**REMARKS**

The application has been reviewed in light of the Non-Final Office Action mailed October 29, 2004. At the time of the Non-Final Office Action, claims 1-26 were pending in this application, and all of these claims were rejected.

### **AMENDMENTS**

ANNOTATED MARK-UP DRAWING

**FIGURE 1**

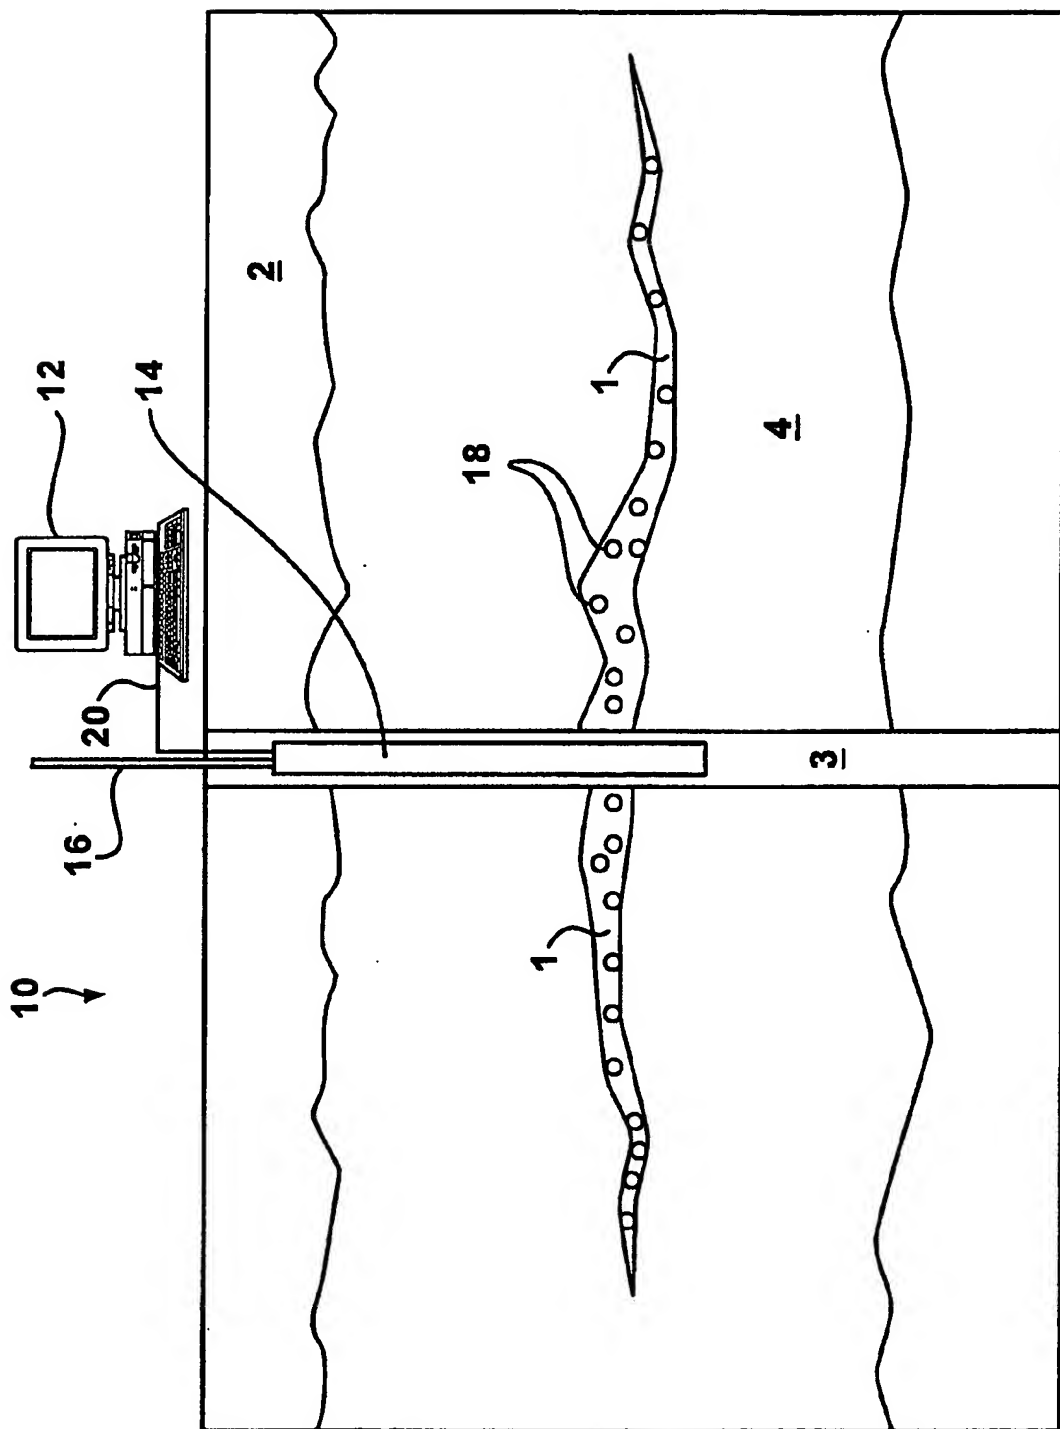
Please replace Figures 1 and 2 with replacement Figures 1-2 and please add new Figures 3-4, which are attached as Exhibit 1 hereto. (A marked-up copy of the drawings is being provided for the convenience of the Examiner and is attached as Exhibit 2 hereto).

~~1/2~~ 1/4

FIGURE 2

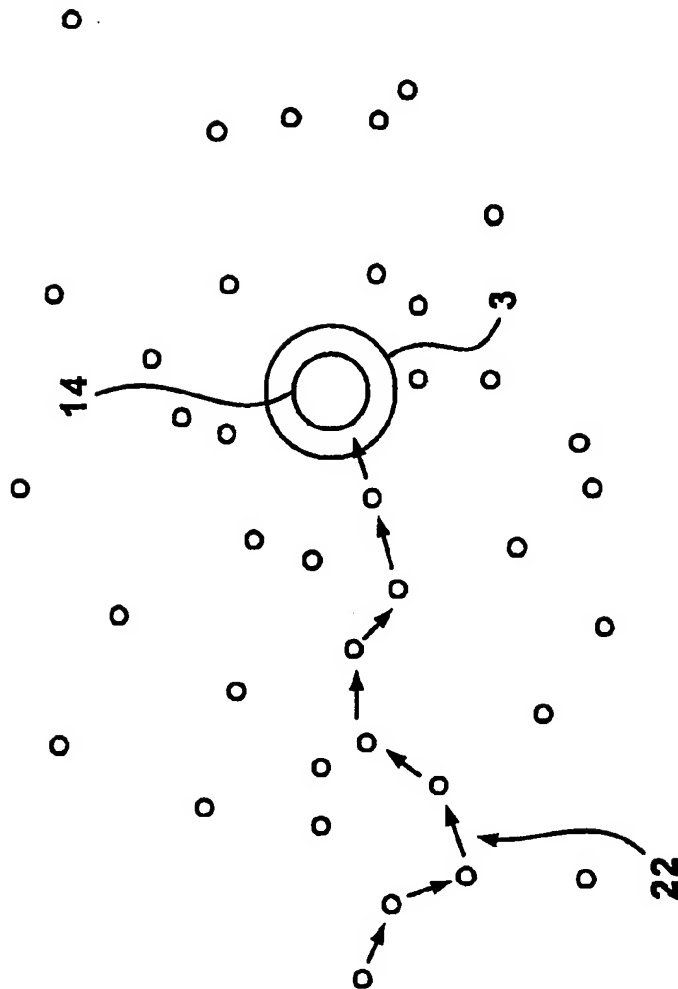
~~2/2~~ 2/4
